"I HEREBY CERTIFY THAT THE LINES AND GRADES OF THE COMPLETED WORK FOR CONTRACT NO. E/4-24 OF THE STORM DRAINAGE FACILITY ALONG THE PENN CENTRAL RAILROAD, NORTH MEADOWS PROJECT, ARE IN SUBSTANTIAL CONFORMANCE WITH THE REQUIREMENTS OF THE CONSTRUCTION PLANS, EXCEPT AS NOTED."

SHEET 4 OF 12 SHEETS		
M.D.C. CODE: 7-14-75 "NORTH MEADOWS REDEVELOPMENT"		
CITY OF HARTFORD, CONNECTICUT DEPARTMENT OF PUBLIC WORKS BUREAU OF ENGINEERING SERVICES		
STORM DRAINAGE FACILITY ALONG RAILROAD NORTH MEADOWS PROJECT		
SUBMITTED	RECOMMENDED	APPROVED
DIVISION ENGINEER	CHIEF OF ENG. SERV.	ACTING DIR. CITY ENG.
DRAWN JED/GR	SCALE AS SHOWN	DAYBOOK NO. 10486E
CHECKED A.A.J.		DATE: FEB. 1974

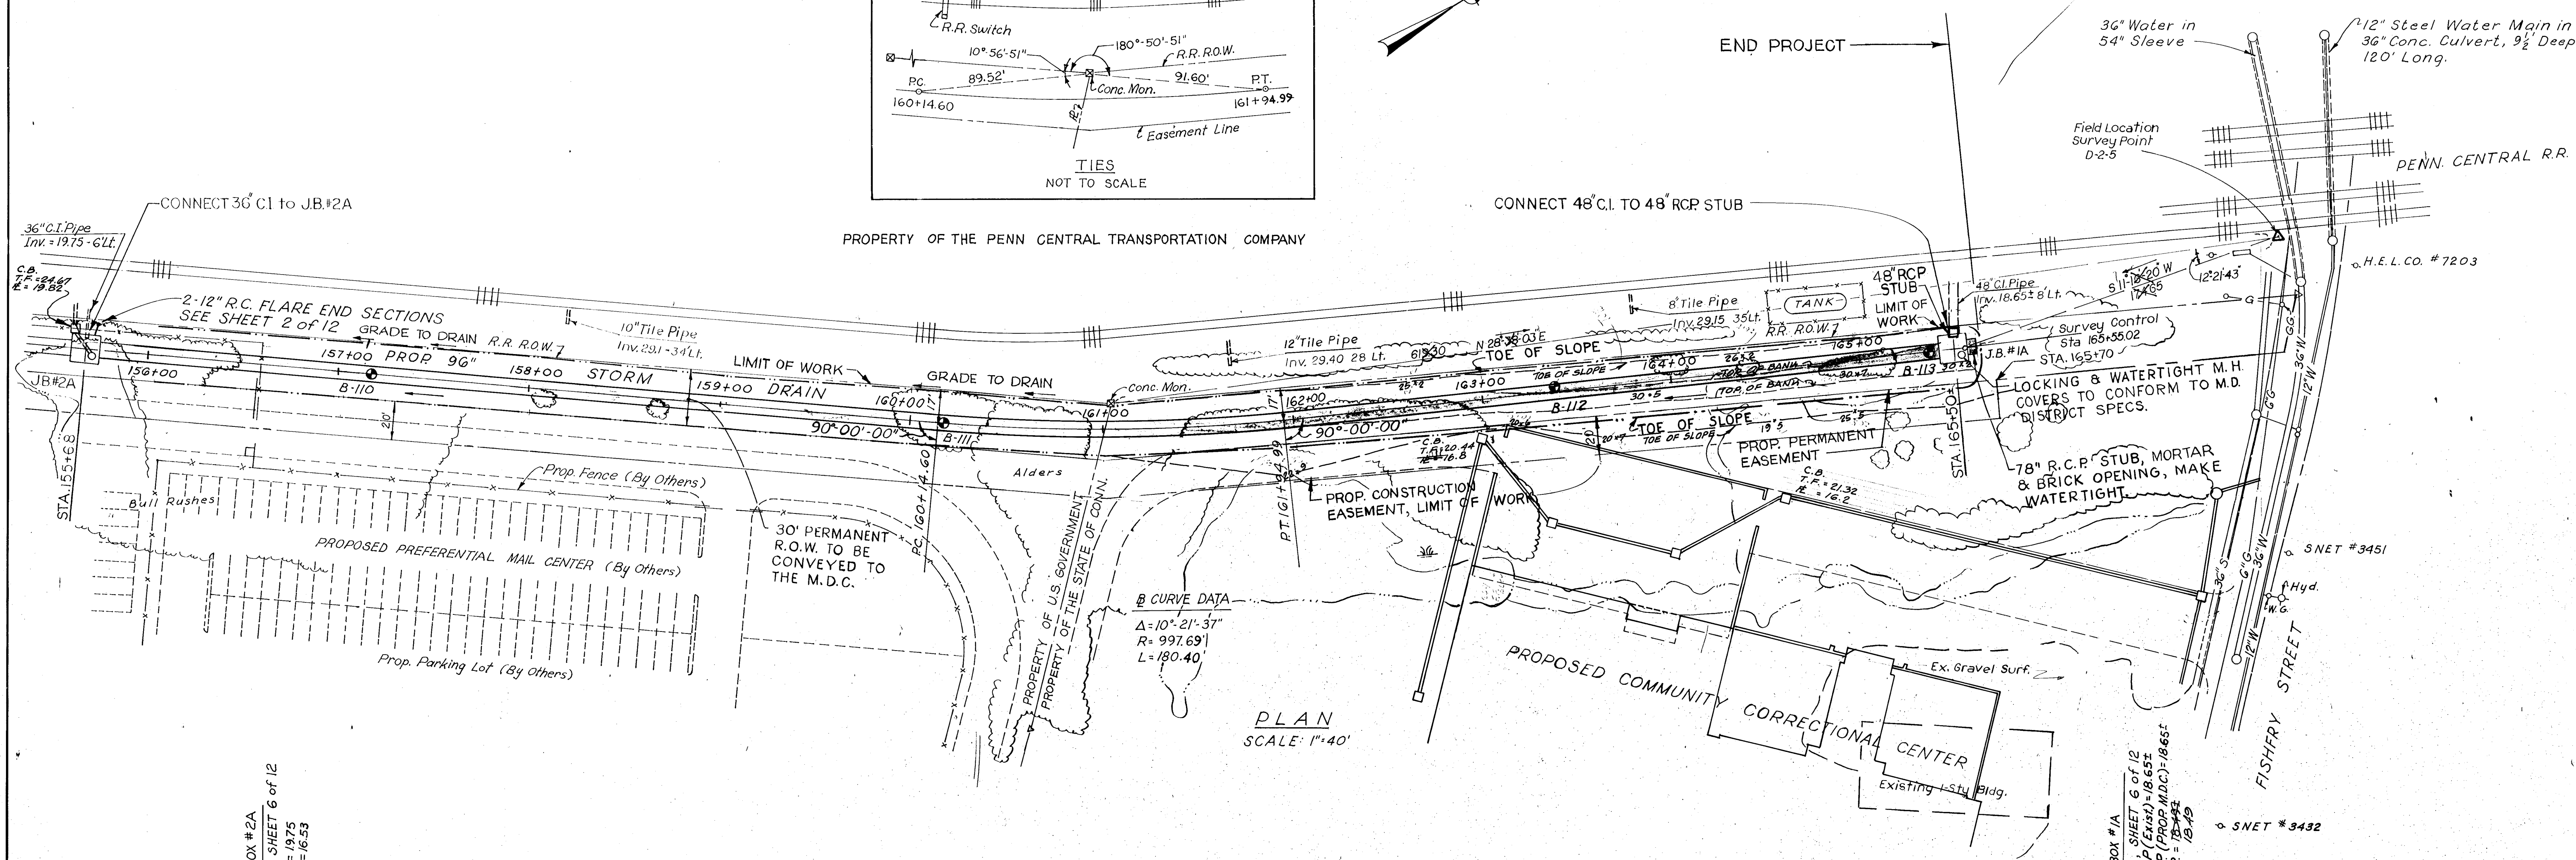
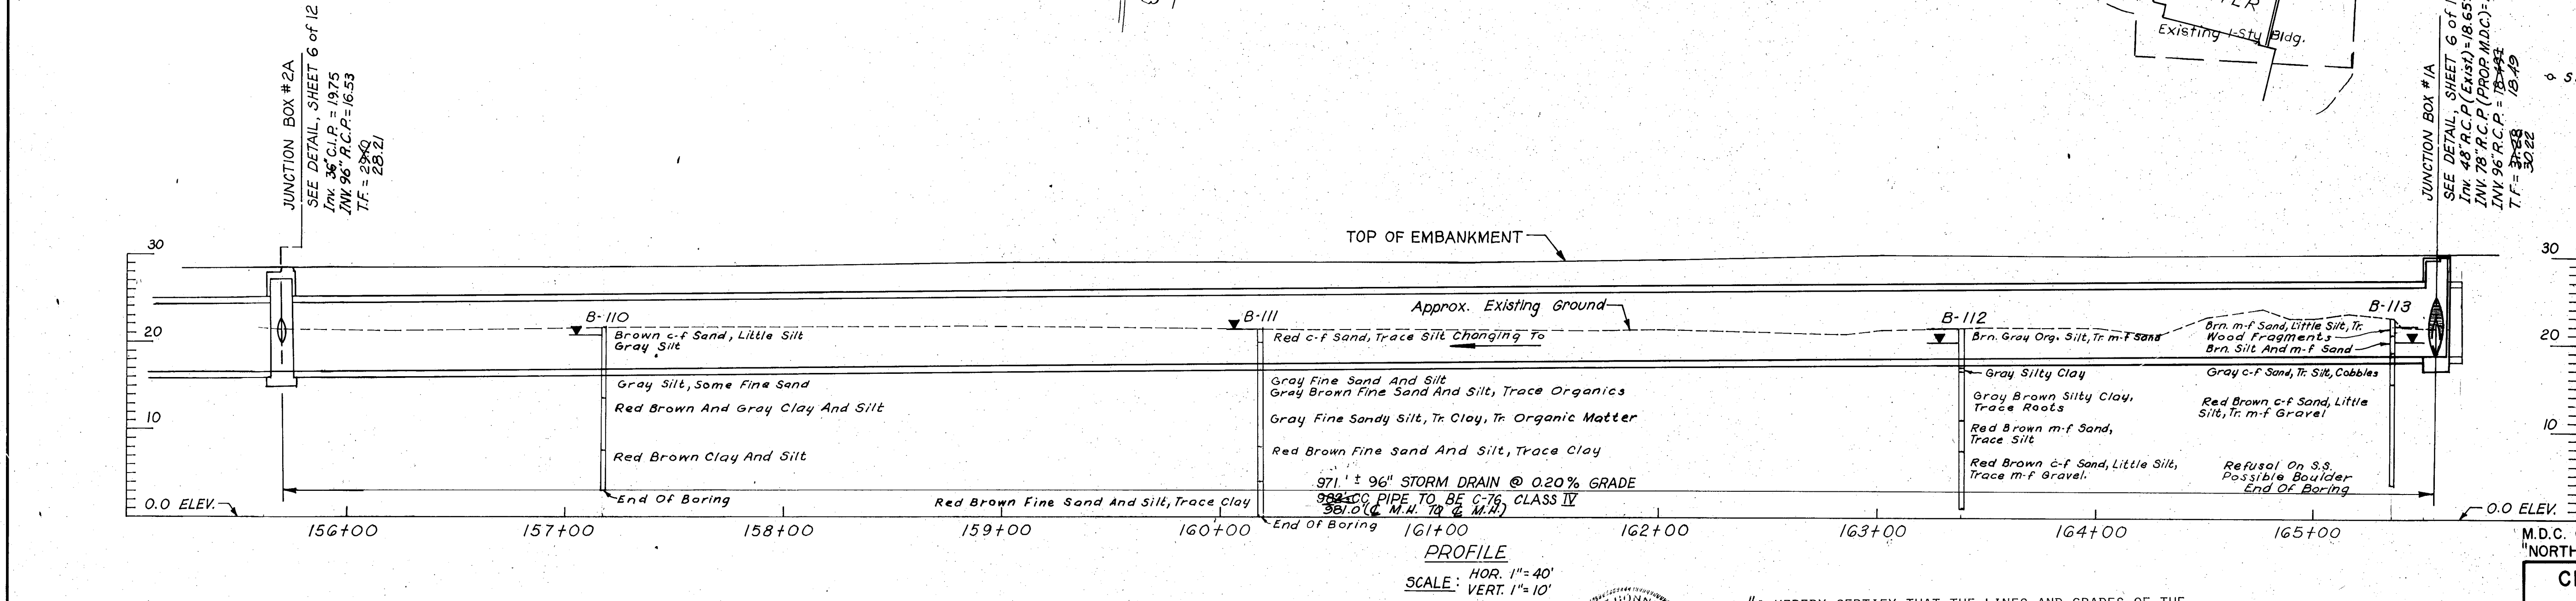
* FILL REQUIRED OVER 36" PIPE BETWEEN STATION 161+00 AND 165+50. NOT PLACED CORRECTLY.
